**Re: E&A Team, Inc. Response to the SC Housing Qualifications Package Checklist**

Enclosed please find E&A Team, Inc.'s Qualification Package for South Carolina Housing.

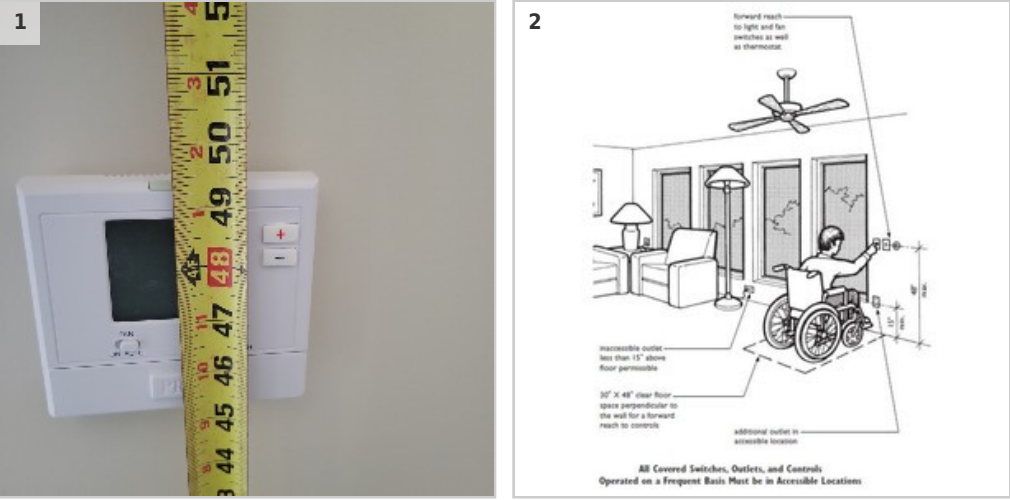
**#96 - Thermostat above 48 inches**  
Priority 2 | Scott Reynolds | 2023-12/11 1st Visit  
Plan: A2.2 - SECOND FLOOR BUILDING PLAN | Location: 208  
Created 12-11-2023

Scott Reynolds	Photo 1	11 Dec 08:33 AM
Alva George	Fair Housing Act Design Manual - Requirement 5 -Light Switches, Electrical Outlets, Thermostats, and Other Environmental Controls in Accessible Locations ANSI A117.1[2003]1004.9 Operable Parts. Lighting controls electrical switches and receptacle outlets, environmental controls, and user controls for security or intercom systems shall comply with Sections 309.2 and 309.3.	14 Dec 10:40 AM
Alva George	Photo 2	14 Dec 10:40 AM
Alva George	Locate controls at 48 inches or below.	14 Dec 10:49 AM

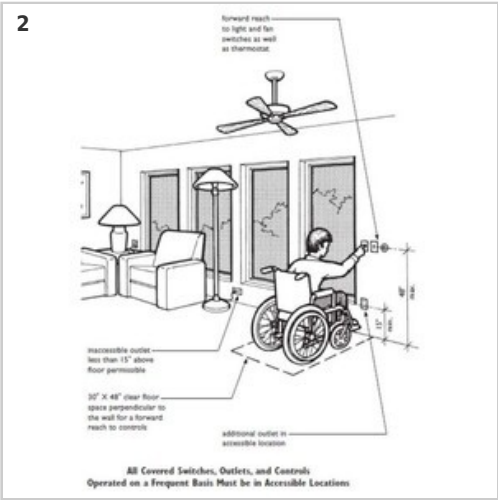
● **#99 - Thermostat above 48 inches**  
Priority 2 | Scott Reynolds | 2023-12/11 1st Visit  
Plan: A2.2 - SECOND FLOOR BUILDING PLAN | Location: 209  
Created 12-11-2023

Scott Reynolds	Photo 1	11 Dec 08:37 AM
Alva George	Fair Housing Act Design Manual - Requirement 5 -Light Switches, Electrical Outlets, Thermostats, and Other Environmental Controls in Accessible Locations ANSI A117.1[2003]1004.9 Operable Parts. Lighting controls electrical switches and receptacle outlets, environmental controls, and user controls for security or intercom systems shall comply with Sections 309.2 and 309.3.	14 Dec 10:40 AM
Alva George	Photo 2	14 Dec 10:41 AM
Alva George	Locate controls at 48 inches or below.	14 Dec 10:50 AM

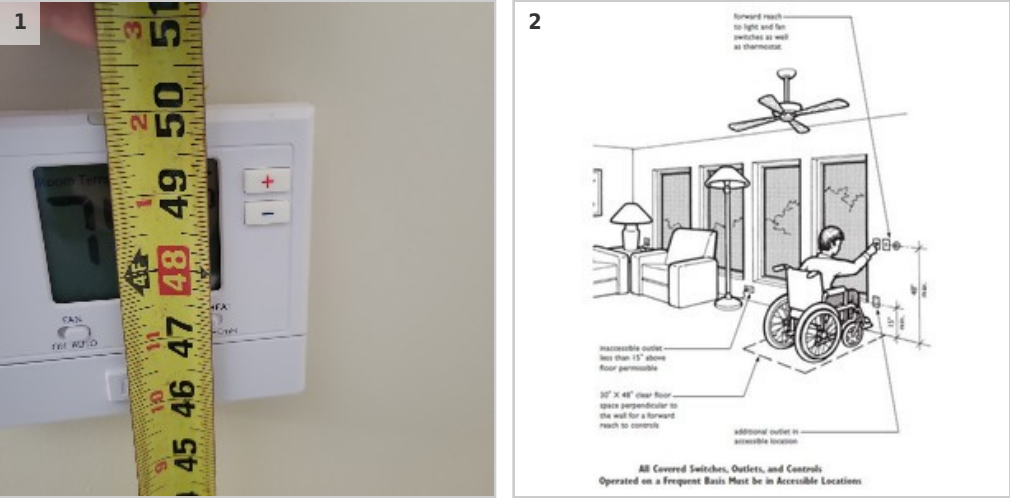
● **#104 - Thermostat above 48 inches**  
Priority 2 | Scott Reynolds | 2023-12/11 1st Visit  
Plan: A2.2 - SECOND FLOOR BUILDING PLAN | Location: 210  
Created 12-11-2023

Scott Reynolds	Photo 1	11 Dec 08:45 AM
Alva George	Fair Housing Act Design Manual - Requirement 5 -Light Switches, Electrical Outlets, Thermostats, and Other Environmental Controls in Accessible Locations ANSI A117.1[2003]1004.9 Operable Parts. Lighting controls electrical switches and receptacle outlets, environmental controls, and user controls for security or intercom systems shall comply with Sections 309.2 and 309.3.	14 Dec 10:42 AM
Alva George	Photo 2	14 Dec 10:42 AM

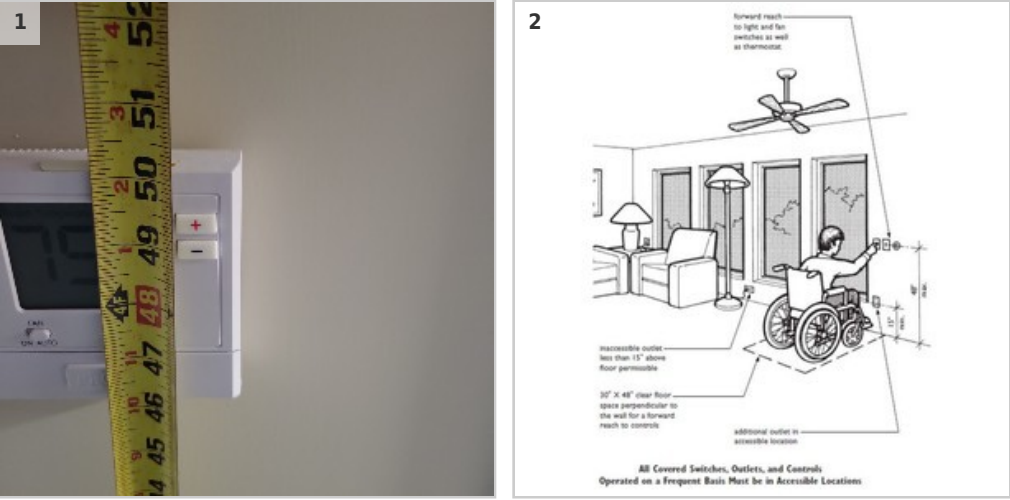
● **#107 - Thermostat above 48 inches**  
Priority 2 | Scott Reynolds | 2023-12/11 1st Visit  
Plan: A2.2 - SECOND FLOOR BUILDING PLAN | Location: 211  
Created 12-11-2023

Scott Reynolds	Photo 1	11 Dec 08:50 AM
Alva George	Fair Housing Act Design Manual - Requirement 5 -Light Switches, Electrical Outlets, Thermostats, and Other Environmental Controls in Accessible Locations ANSI A117.1[2003]1004.9 Operable Parts. Lighting controls electrical switches and receptacle outlets, environmental controls, and user controls for security or intercom systems shall comply with Sections 309.2 and 309.3.	14 Dec 10:50 AM
Alva George	Photo 2	14 Dec 10:50 AM
Alva George	Locate controls at 48 inches or below.	14 Dec 10:51 AM

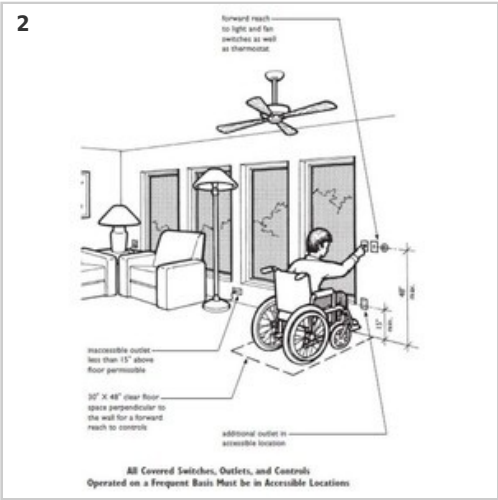
● **#110 - Thermostat above 48 inches**  
Priority 2 | Scott Reynolds | 2023-12/11 1st Visit  
Plan: A2.2 - SECOND FLOOR BUILDING PLAN | Location: 212  
Created 12-11-2023

Scott Reynolds	Photo 1	11 Dec 08:54 AM
Alva George	Fair Housing Act Design Manual - Requirement 5 -Light Switches, Electrical Outlets, Thermostats, and Other Environmental Controls in Accessible Locations ANSI A117.1[2003]1004.9 Operable Parts. Lighting controls electrical switches and receptacle outlets, environmental controls, and user controls for security or intercom systems shall comply with Sections 309.2 and 309.3.	14 Dec 10:46 AM
Alva George	Photo 2	14 Dec 10:47 AM
Alva George	Locate controls at 48 inches or below.	14 Dec 10:51 AM

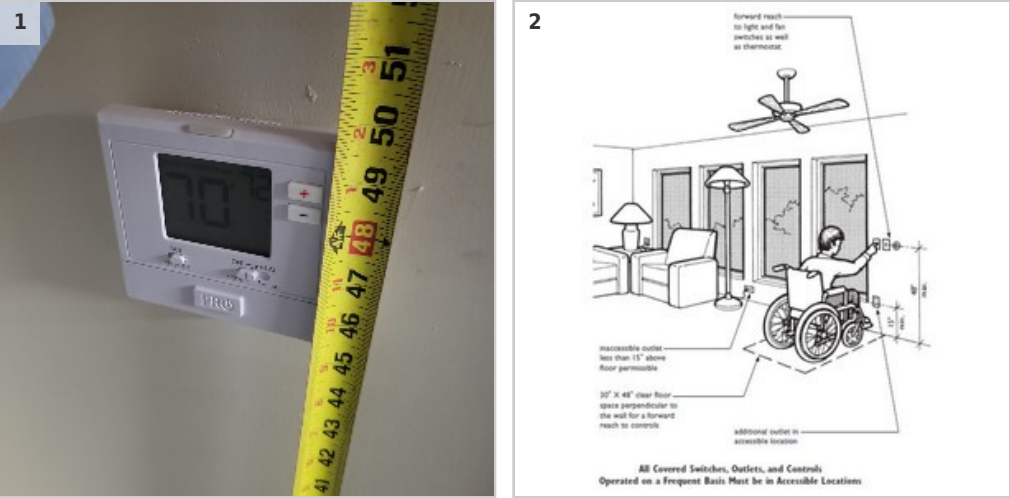
● **#113 - Thermostat above 48 inches**  
Priority 2 | Scott Reynolds | 2023-12/11 1st Visit  
Plan: A2.2 - SECOND FLOOR BUILDING PLAN | Location: 213  
Created 12-11-2023

Scott Reynolds	Photo 1	11 Dec 08:58 AM
Alva George	Fair Housing Act Design Manual - Requirement 5 -Light Switches, Electrical Outlets, Thermostats, and Other Environmental Controls in Accessible Locations ANSI A117.1[2003]1004.9 Operable Parts. Lighting controls electrical switches and receptacle outlets, environmental controls, and user controls for security or intercom systems shall comply with Sections 309.2 and 309.3.	14 Dec 10:46 AM
Alva George	Photo 2	14 Dec 10:47 AM

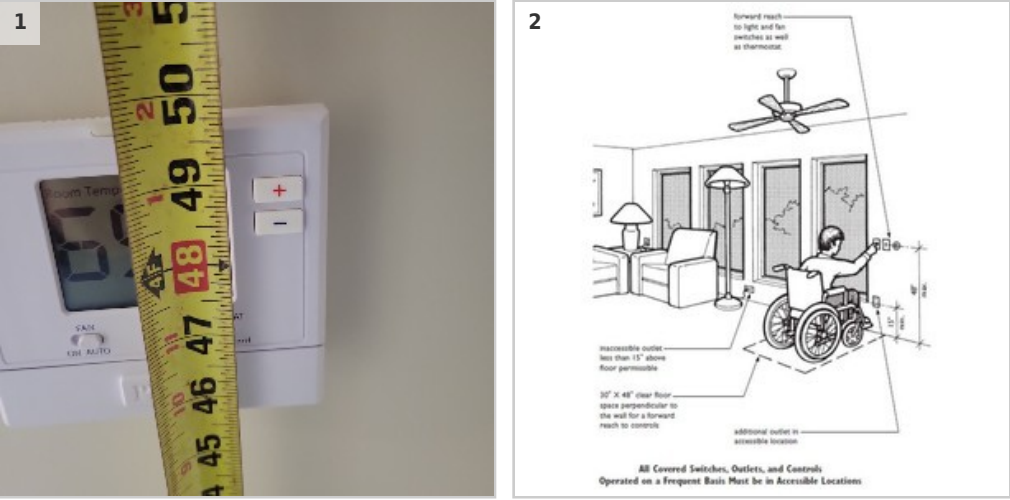
**#123 - Thermostat above 48 inches**  
Priority 2 | Scott Reynolds | 2023-12/11 1st Visit  
Plan: A2.3 - THIRD FLOOR BUILDING PLAN | Location: 301  
Created 12-11-2023

Scott Reynolds	Photo 1	11 Dec 09:17 AM
Alva George	Fair Housing Act Design Manual - Requirement 5 -Light Switches, Electrical Outlets, Thermostats, and Other Environmental Controls in Accessible Locations ANSI A117.1[2003]1004.9 Operable Parts. Lighting controls electrical switches and receptacle outlets, environmental controls, and user controls for security or intercom systems shall comply with Sections 309.2 and 309.3.	14 Dec 10:48 AM
Alva George	Photo 2	14 Dec 10:48 AM
Alva George	Locate controls at 48 inches or below.	14 Dec 10:48 AM

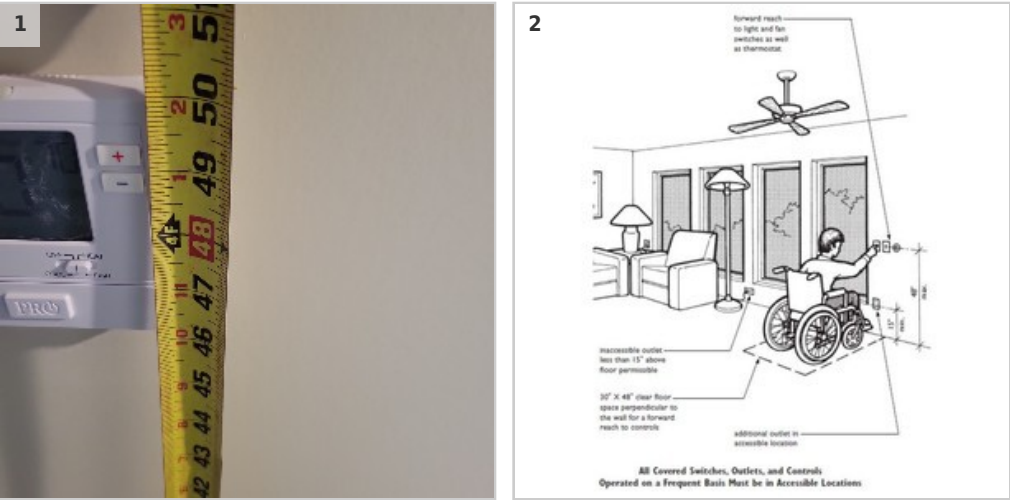
● **#130 - Thermostat above 48 inches**  
Priority 2 | Scott Reynolds | 2023-12/11 1st Visit  
Plan: A2.3 - THIRD FLOOR BUILDING PLAN | Location: 304  
Created 12-11-2023

Task messages (time in PDT)		
Scott Reynolds	Photo 1	11 Dec 09:27 AM
Alva George	Fair Housing Act Design Manual - Requirement 5 -Light Switches, Electrical Outlets, Thermostats, and Other Environmental Controls in Accessible Locations ANSI A117.1[2003]1004.9 Operable Parts. Lighting controls electrical switches and receptacle outlets, environmental controls, and user controls for security or intercom systems shall comply with Sections 309.2 and 309.3.	14 Dec 10:52 AM
Alva George	Photo 2	14 Dec 10:52 AM
Alva George	Locate controls at 48 inches or below.	14 Dec 10:59 AM

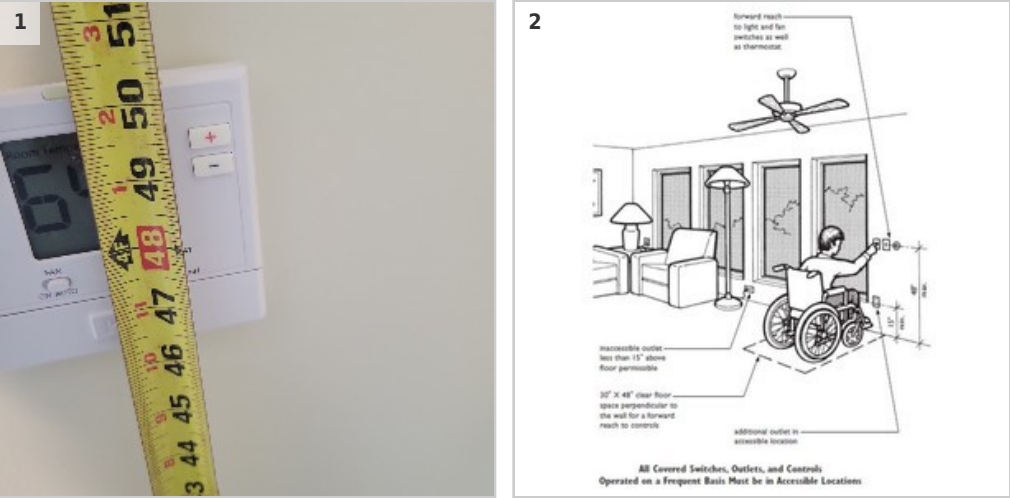
● **#134 - Thermostat above 48 inches**  
Priority 2 | Scott Reynolds | 2023-12/11 1st Visit  
Plan: A2.3 - THIRD FLOOR BUILDING PLAN | Location: 305  
Created 12-11-2023

Task messages (time in PDT)		
Scott Reynolds	Photo 1	11 Dec 09:32 AM
Alva George	Fair Housing Act Design Manual - Requirement 5 -Light Switches, Electrical Outlets, Thermostats, and Other Environmental Controls in Accessible Locations ANSI A117.1[2003]1004.9 Operable Parts. Lighting controls electrical switches and receptacle outlets, environmental controls, and user controls for security or intercom systems shall comply with Sections 309.2 and 309.3.	14 Dec 11:00 AM
Alva George	Photo 2	14 Dec 11:00 AM

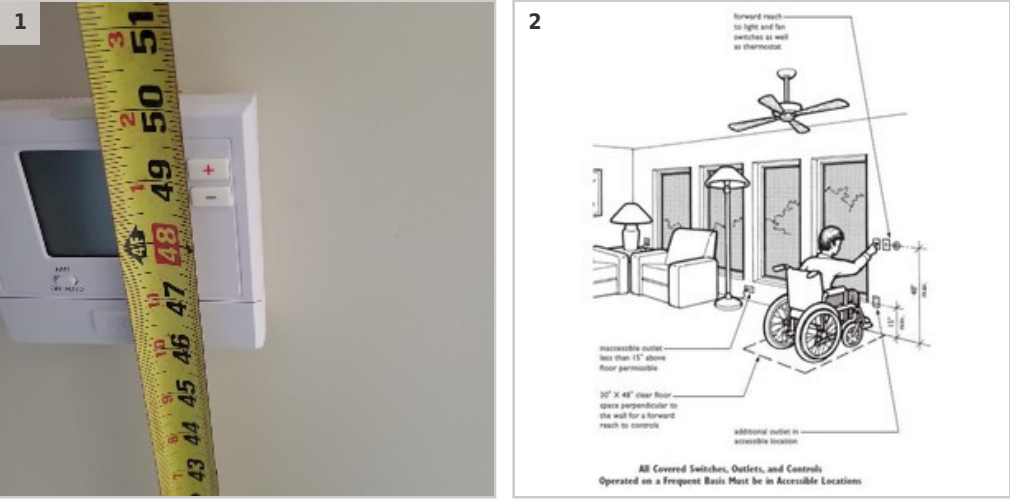
● **#138 - Thermostat above 48 inches**  
Priority 2 | Scott Reynolds | 2023-12/11 1st Visit  
Plan: A2.3 - THIRD FLOOR BUILDING PLAN | Location: 306  
Created 12-11-2023

Scott Reynolds	Photo 1	11 Dec 09:37 AM
Alva George	Fair Housing Act Design Manual - Requirement 5 -Light Switches, Electrical Outlets, Thermostats, and Other Environmental Controls in Accessible Locations ANSI A117.1[2003]1004.9 Operable Parts. Lighting controls electrical switches and receptacle outlets, environmental controls, and user controls for security or intercom systems shall comply with Sections 309.2 and 309.3.	14 Dec 11:01 AM
Alva George	Photo 2	14 Dec 11:01 AM
Alva George	Locate controls at 48 inches or below.	14 Dec 11:04 AM

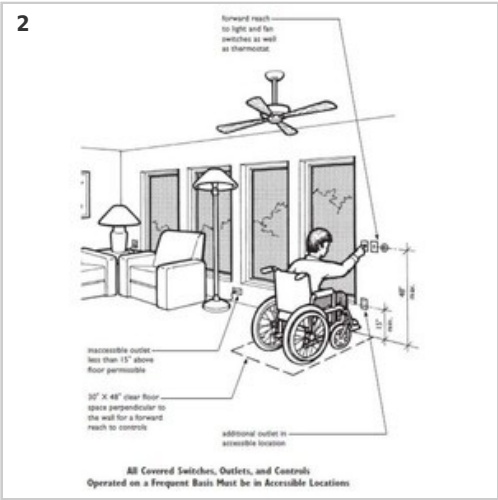
● **#141 - Thermostat above 48 inches**  
Priority 2 | Scott Reynolds | 2023-12/11 1st Visit  
Plan: A2.3 - THIRD FLOOR BUILDING PLAN | Location: 307  
Created 12-11-2023

Scott Reynolds	Photo 1	11 Dec 09:40 AM
Alva George	Fair Housing Act Design Manual - Requirement 5 -Light Switches, Electrical Outlets, Thermostats, and Other Environmental Controls in Accessible Locations ANSI A117.1[2003]1004.9 Operable Parts. Lighting controls electrical switches and receptacle outlets, environmental controls, and user controls for security or intercom systems shall comply with Sections 309.2 and 309.3.	14 Dec 11:01 AM
Alva George	Photo 2	14 Dec 11:01 AM
Alva George	Locate controls at 48 inches or below.	14 Dec 11:05 AM

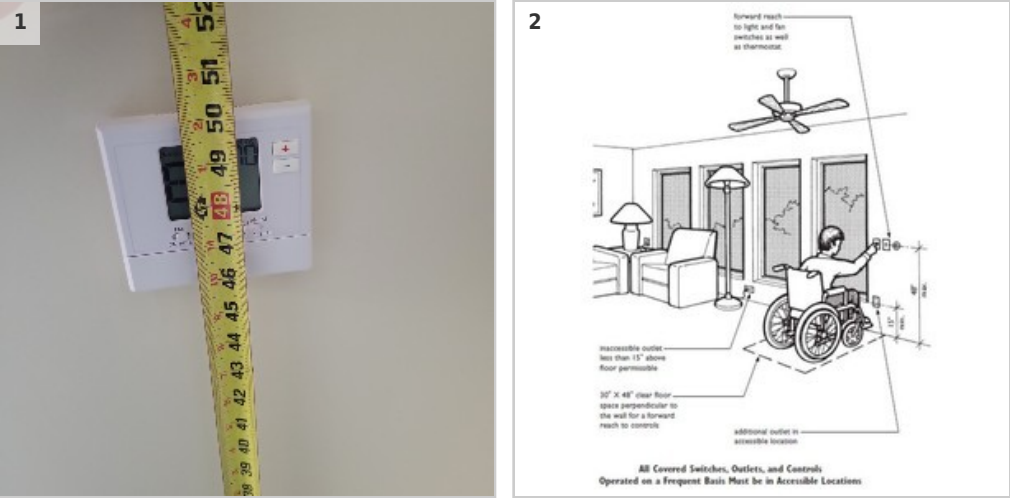
● **#144 - Thermostat above 48 inches**  
Priority 2 | Scott Reynolds | 2023-12/11 1st Visit  
Plan: A2.3 - THIRD FLOOR BUILDING PLAN | Location: 308  
Created 12-11-2023

Scott Reynolds	Photo 1	11 Dec 09:43 AM
Alva George	Fair Housing Act Design Manual - Requirement 5 -Light Switches, Electrical Outlets, Thermostats, and Other Environmental Controls in Accessible Locations ANSI A117.1[2003]1004.9 Operable Parts. Lighting controls electrical switches and receptacle outlets, environmental controls, and user controls for security or intercom systems shall comply with Sections 309.2 and 309.3.	14 Dec 11:02 AM
Alva George	Photo 2	14 Dec 11:05 AM

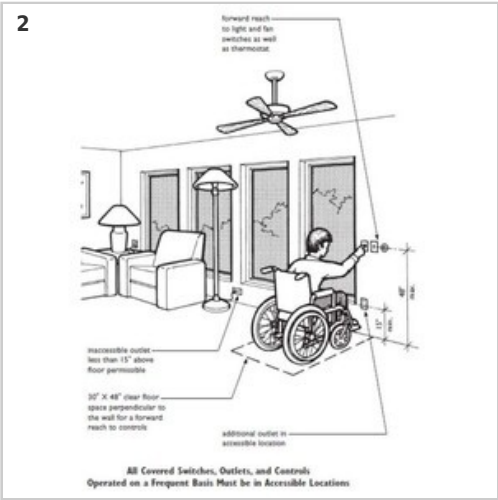
● **#150 - Thermostat above 48 inches**  
Priority 2 | Scott Reynolds | 2023-12/11 1st Visit  
Plan: A2.3 - THIRD FLOOR BUILDING PLAN | Location: 310  
Created 12-11-2023

Scott Reynolds	Photo 1	11 Dec 09:49 AM
Alva George	Fair Housing Act Design Manual - Requirement 5 -Light Switches, Electrical Outlets, Thermostats, and Other Environmental Controls in Accessible Locations ANSI A117.1[2003]1004.9 Operable Parts. Lighting controls electrical switches and receptacle outlets, environmental controls, and user controls for security or intercom systems shall comply with Sections 309.2 and 309.3.	14 Dec 11:07 AM
Alva George	Photo 2	14 Dec 11:07 AM
Alva George	Locate controls at 48 inches or below.	14 Dec 11:12 AM

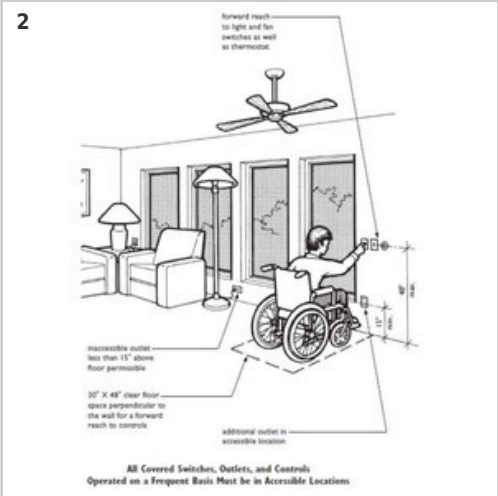
● **#154 - Thermostat above 48 inches**  
Priority 2 | Scott Reynolds | 2023-12/11 1st Visit  
Plan: A2.3 - THIRD FLOOR BUILDING PLAN | Location: 311  
Created 12-11-2023

Scott Reynolds	Photo 1	11 Dec 09:54 AM
Alva George	Fair Housing Act Design Manual - Requirement 5 -Light Switches, Electrical Outlets, Thermostats, and Other Environmental Controls in Accessible Locations ANSI A117.1[2003]1004.9 Operable Parts. Lighting controls electrical switches and receptacle outlets, environmental controls, and user controls for security or intercom systems shall comply with Sections 309.2 and 309.3.	14 Dec 11:07 AM
Alva George	Photo 2	14 Dec 11:08 AM

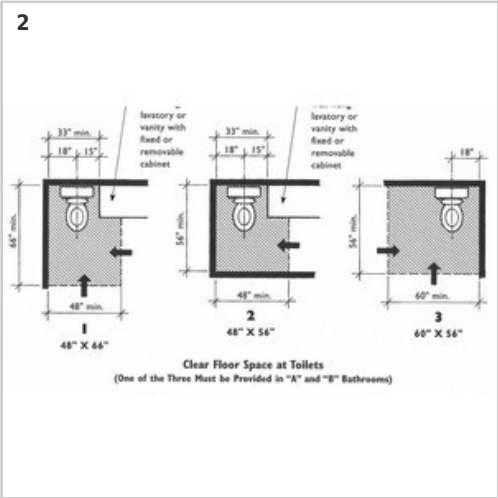
● #155 - The toilet is not 18 inches from the side wall.- Provide clear floor space at the water closet.

Priority 2 | Scott Reynolds | 2023-12/11 1st Visit  
Plan: A2.3 - THIRD FLOOR BUILDING PLAN | Location: 311  
Created 12-11-2023

Scott Reynolds	Photo 1	11 Dec 09:54 AM
Alva George	Fair Housing Act Design Manual - Requirement 7 Usable Kitchens and Bathrooms Part A:Usable Kitchens Part B: Usable Bathrooms	14 Dec 11:21 AM
Alva George	Photo 2	14 Dec 11:21 AM

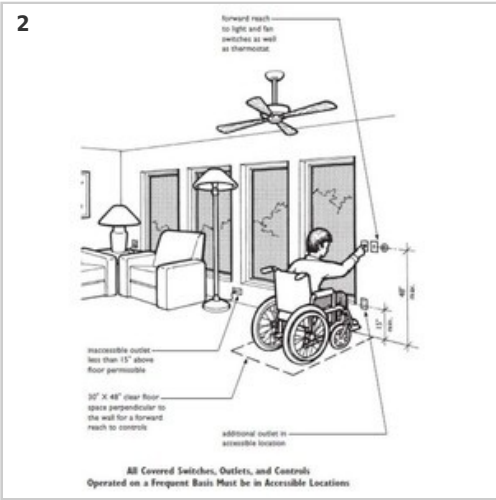
● **#158 - Thermostat above 48 inches**  
Priority 2 | Scott Reynolds | 2023-12/11 1st Visit  
Plan: A2.3 - THIRD FLOOR BUILDING PLAN | Location: 312  
Created 12-11-2023

Scott Reynolds	Photo 1	11 Dec 09:59 AM
Alva George	Fair Housing Act Design Manual - Requirement 5 -Light Switches, Electrical Outlets, Thermostats, and Other Environmental Controls in Accessible Locations ANSI A117.1[2003]1004.9 Operable Parts. Lighting controls electrical switches and receptacle outlets, environmental controls, and user controls for security or intercom systems shall comply with Sections 309.2 and 309.3.	14 Dec 11:08 AM
Alva George	Photo 2	14 Dec 11:10 AM
Alva George	Locate controls at 48 inches or below.	14 Dec 11:10 AM

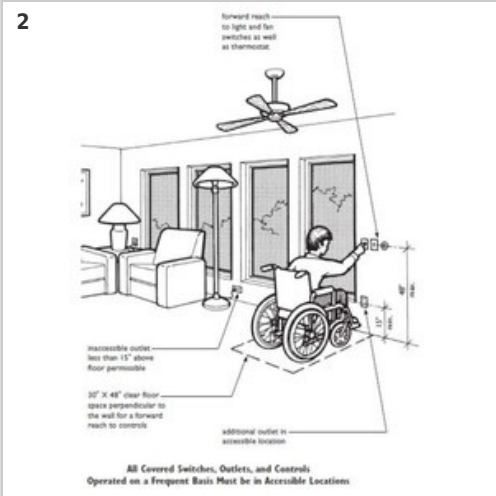
● **#161 - Thermostat above 48 inches**  
Priority 2 | Scott Reynolds | 2023-12/11 1st Visit  
Plan: A2.3 - THIRD FLOOR BUILDING PLAN | Location: 313  
Created 12-11-2023

Scott Reynolds	Photo 1	11 Dec 10:02 AM
Alva George	Fair Housing Act Design Manual - Requirement 5 -Light Switches, Electrical Outlets, Thermostats, and Other Environmental Controls in Accessible Locations ANSI A117.1[2003]1004.9 Operable Parts. Lighting controls electrical switches and receptacle outlets, environmental controls, and user controls for security or intercom systems shall comply with Sections 309.2 and 309.3.	14 Dec 11:09 AM
Alva George	Photo 2	14 Dec 11:09 AM

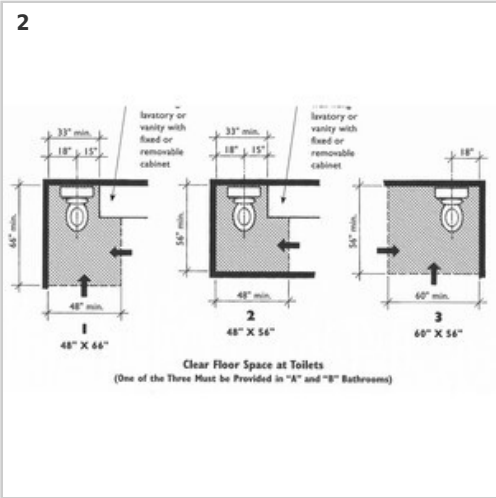
● #166 - The toilet is not 18 inches from the side wall.- Provide clear floor space at the water closet.

Priority 2 | Scott Reynolds | 2023-12/11 1st Visit  
Plan: A2.3 - THIRD FLOOR BUILDING PLAN | Location: 315  
Created 12-11-2023

Scott Reynolds	Photo 1	11 Dec 10:08 AM
Alva George	Fair Housing Act Design Manual - Requirement 7 Usable Kitchens and Bathrooms Part A:Usable Kitchens Part B: Usable Bathrooms	14 Dec 11:21 AM
Alva George	Photo 2	14 Dec 11:22 AM

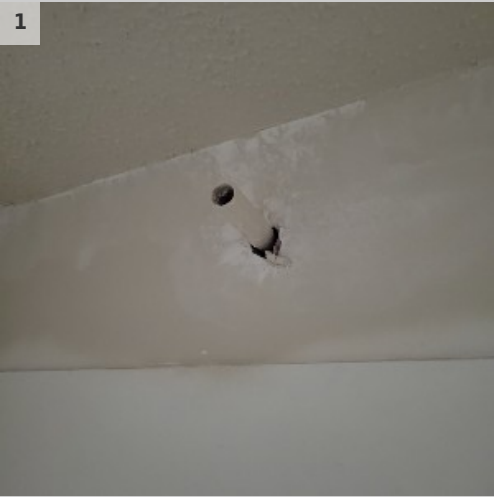
Priority 2 | Scott Reynolds | 2023-12/11 1st Visit  
Plan: A2.1 - FIRST FLOOR BUILDING PLAN | Location: accessible 107  
Created 12-11-2023

Scott Reynolds	Photo 1	11 Dec 07:16 AM
Alva George	UFAS 4.34.5.5 SHOWERS. If a shower is provided, it shall have the following features:(5) Shower unit. A shower spray unit with a hose at least 60 in (1525 mm) long that can be used as a fixed shower head at various heights or as a hand-held shower shall be provided.	13 Dec 07:30 AM

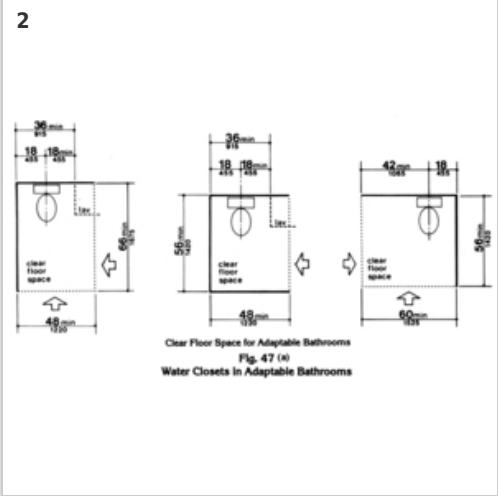
Priority 2 | Scott Reynolds | 2023-12/11 1st Visit  
Plan: A2.1 - FIRST FLOOR BUILDING PLAN | Location: accessible 108  
Created 12-11-2023

Scott Reynolds	Photo 1	11 Dec 07:15 AM
Alva George	UFAS 4.34.5.2 WATER CLOSETS.	13 Dec 07:15 AM
(1) Clear floor space at the water closet shall be as shown in Fig. 47(a). The water closet may be located with the clear area at either the right or left side of the toilet.		
Alva George	Photo 2	13 Dec 07:15 AM
